PLANNING, ZONING, & BUILDING DEPARTMENT
PZ&B Staff Combination Memorandum: Architectural Commission and Town Council

SUBJECT: ARC-23-088 (ZON-23-086) 292 ORANGE GROVE RD (COMBO)

MEETING: SEPTEMBER 27, 2023

ARC-23-088 (ZON-23-086) 292 ORANGE GROVE RD (COMBO). The applicants, Stephen and Kerri Meyers, have filed an application requesting Architectural Commission review and approval for the construction of a new two-story single-family residence with sitewide landscape and hardscape improvements, requiring (1) variance for Cubic Content. The Town Council shall review the application as it pertains to the zoning relief/approval.

**Cubic Content AXO at 7.26’ Zero Datum
 Plan Sheet SP-1.03**

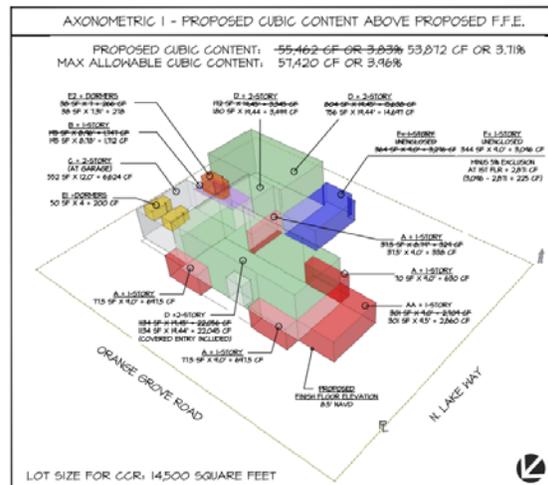
The exiting residence to be demolished has an entry threshold/Finish Floor Elevation of 9.55’ NAVD, and the applicant is electing to place the proposed Finished Floor at 8.5’ NAVD. The application includes an axonometric diagram which demonstrates that if the Cubic Content calculation utilized the proposed Finish Floor Elevation of 8.5” NAVD in lieu of the code prescribed 7.26’ NAVD Zero Datum as the bottom plane of the volumetric measurement, the proposal would be conforming with allowable Cubic Content provisions. As the Zero Datum cannot be changed, the applicant has requested **Variance 1** for the cubic content ratio overage:

The current cubic content overage proposed is 1,070 CF, which is 1,758 CF smaller than the overage amount of 2,828 CF proposed in the previous iteration reviewed at the August ARCOM meeting. Although the application requires a Cubic Content variance, the applicant has achieved a project which still conforms to the height and overall height requirements.
